HAMILTON PARK
REZONING PLAN
SOUTH-WEST CORNER OF THE INTERSECTION OF
STEELE CREEK ROAD AND HAMILTON ROAD
CHARLOTTE, NORTH CAROLINA 28273

PROJECT NO:	RTD-18000
FILENAME:	RTD-18000-RZ1
CHECKED BY:	RMR
DRAWN BY:	JDL
SCALE:	1"=40'
DATE:	06-05-2018
SHEET NO:	RZ-1

**R2 DEVELOPMENT – HAMILTON PARK
REZONING PETITION 2018-077
RESPONSE LETTER – 09-26-2018**

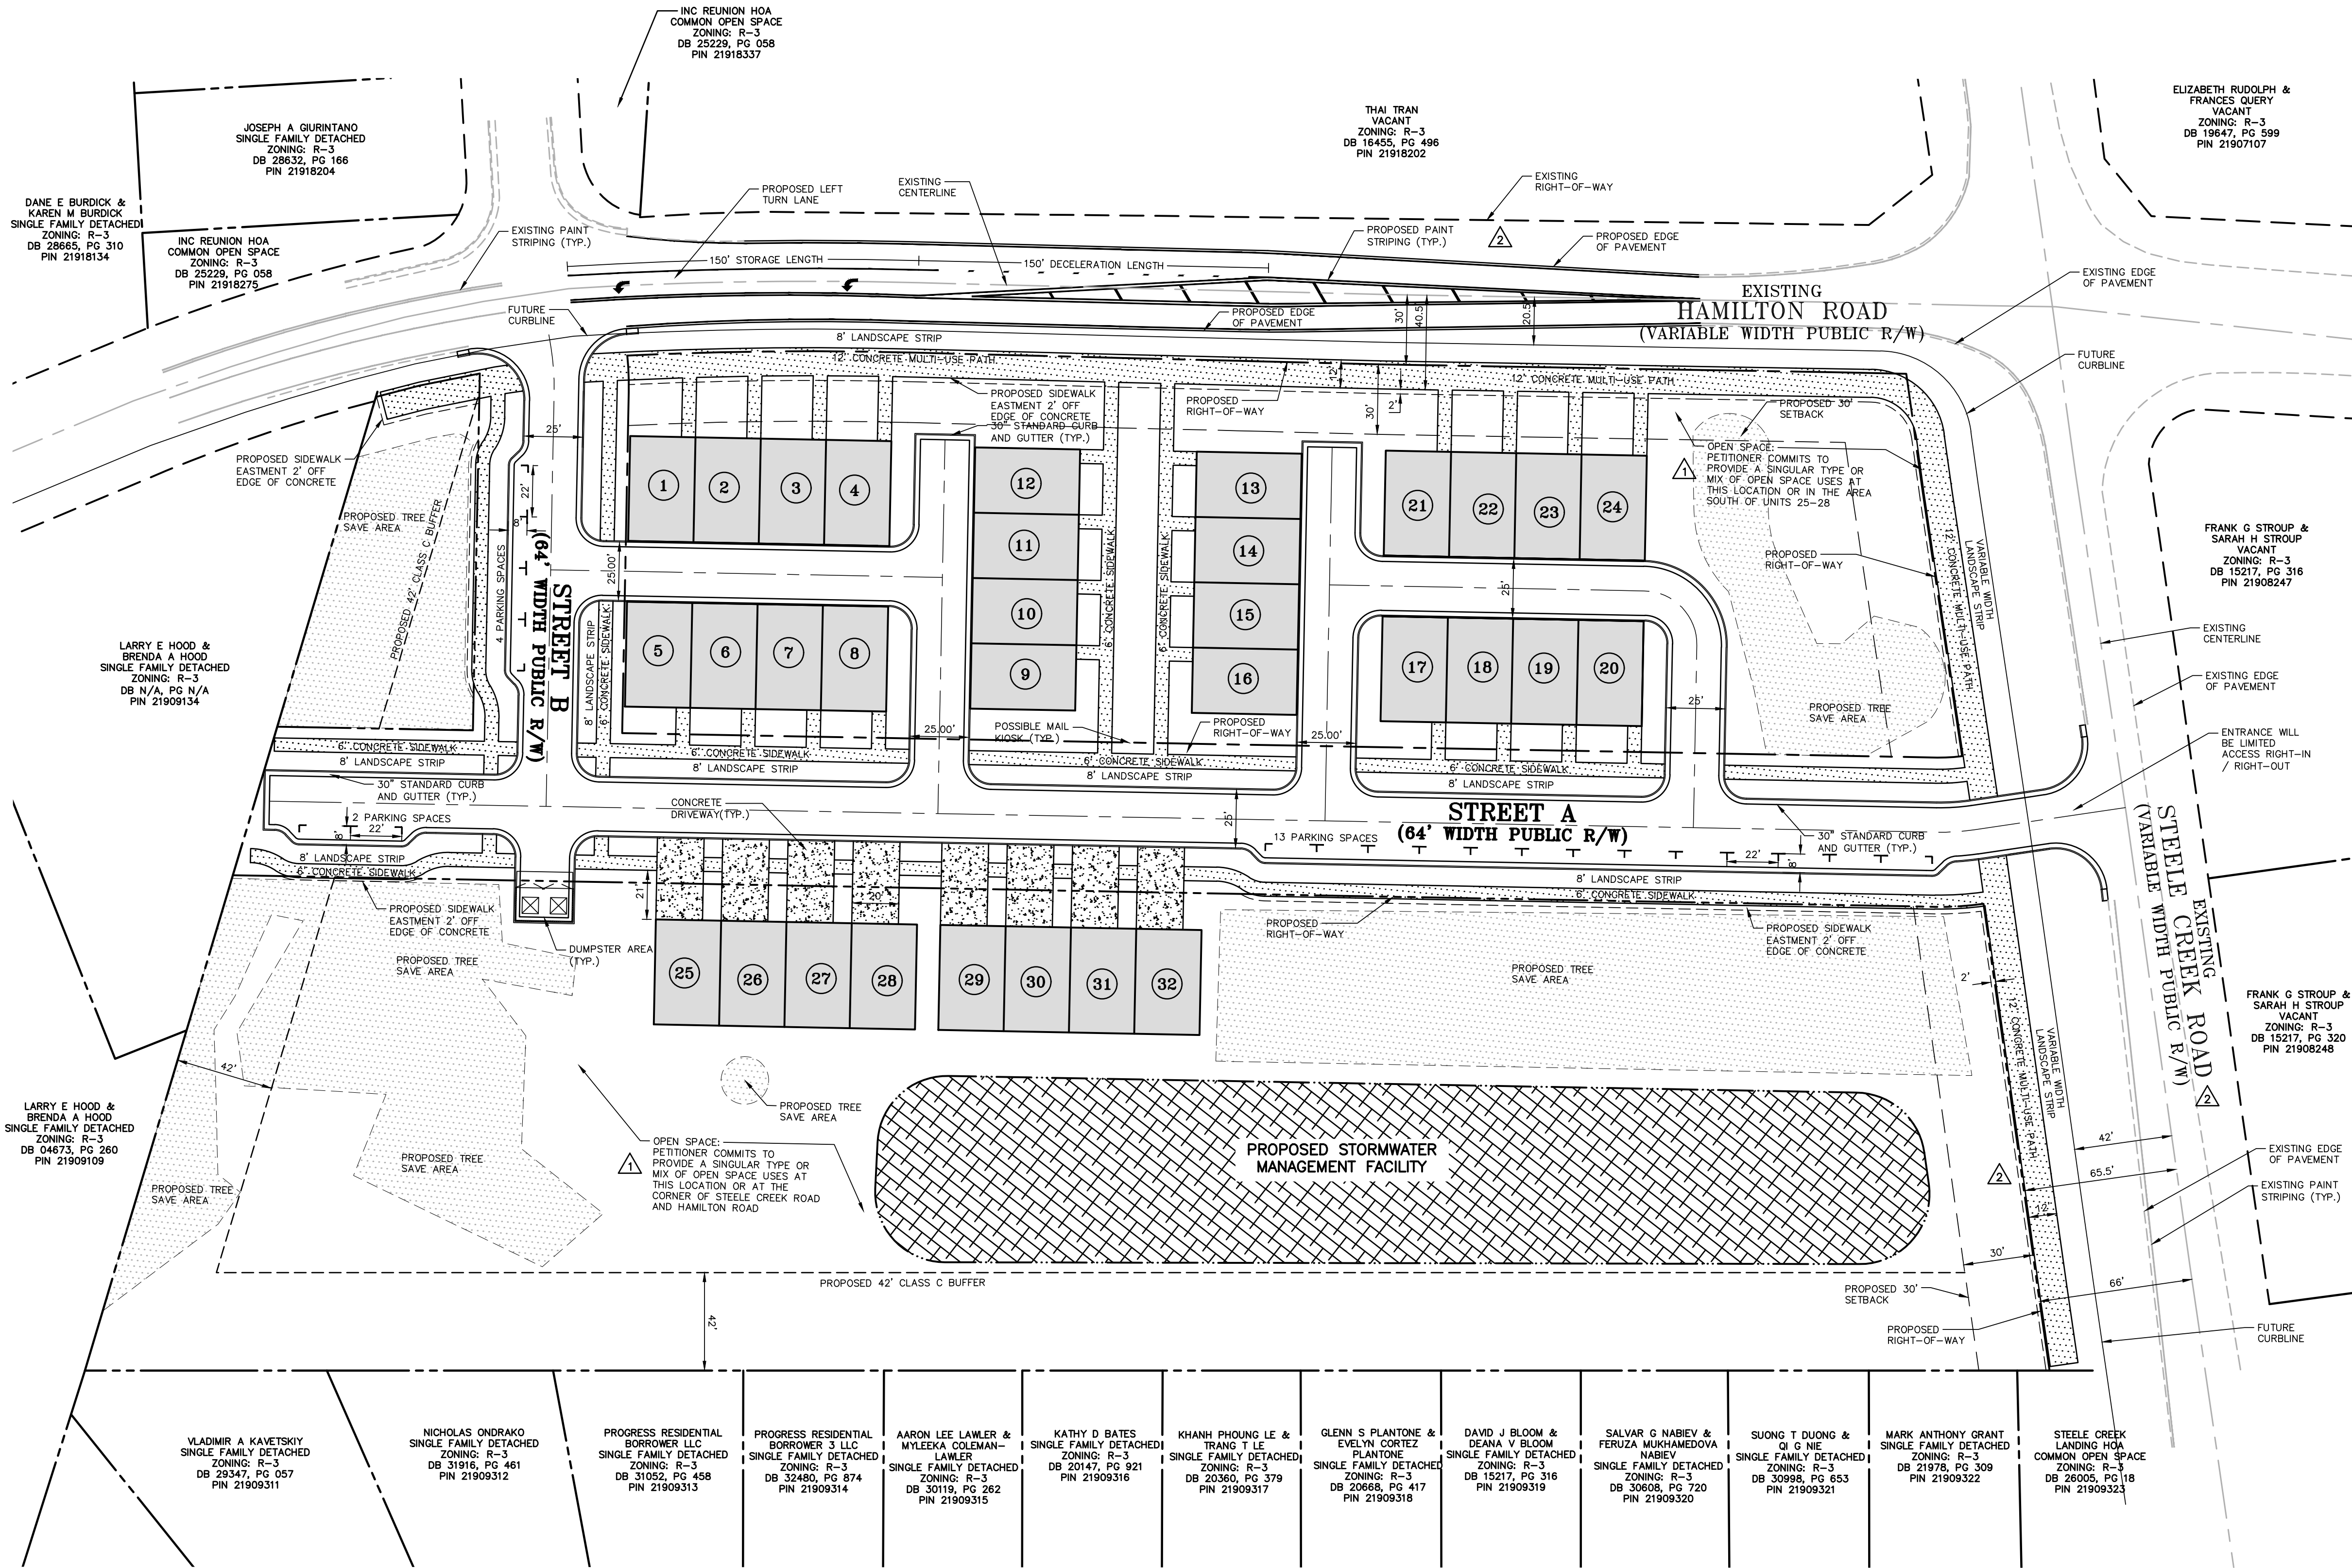
1. **Curbline** The proposed zoning district has a setback measured from back of the existing or proposed future curbline. The proposed cross section for the NCDOT widening project U-5766 has been updated. Based on the new cross section, the location of the future back-of-curb for:

- a. Steele Creek Road – 42 feet from centerline of the road (reduced from 53 feet)
- b. Hamilton Road – 20.5 feet from centerline of the road (reduced from 28 feet)

2. Revise the site plan to show:

- i. The back of multi-use path on Steele Creek Road located 65.5 feet from centerline of the road.
- ii. The back of multi-use path on Hamilton located 40.5 feet from centerline of the of the road.

- i. The back of multi-use path on Steele Creek Road located 65.5 feet from centerline of the road.
 - ii. The back of multi-use path on Hamilton located 40.5 feet from centerline of the of the road.
3. The right-of-way is shown incorrectly in the update site plan. Furthermore, the updated cross-section for the NCDOT widening project U-5766 has changed the right-of way. The petitioner should revise the site plan and conditional notes to show the dedication of right-of-way, fee simple, of 66 feet from centerline of Steele Creek Road (reduced from 75 feet).

4. The petitioner should revise the site plan to show the correct existing right-of-way on Hamilton Rd of 60 feet wide total, 30 feet from centerline of the road.

Response: Revised curblines from the centerlines of the roads have been provided:

- a. Steele Creek Road – 42 feet from centerline of the road
- b. Hamilton Road – 20.5 feet from centerline of the road

Response: The site plan has been revised to show:

Response: The ROW for Steele Creek Road has been revised to reflect the above.

Response: The ROW for Hamilton Road has been revised to reflect the above.
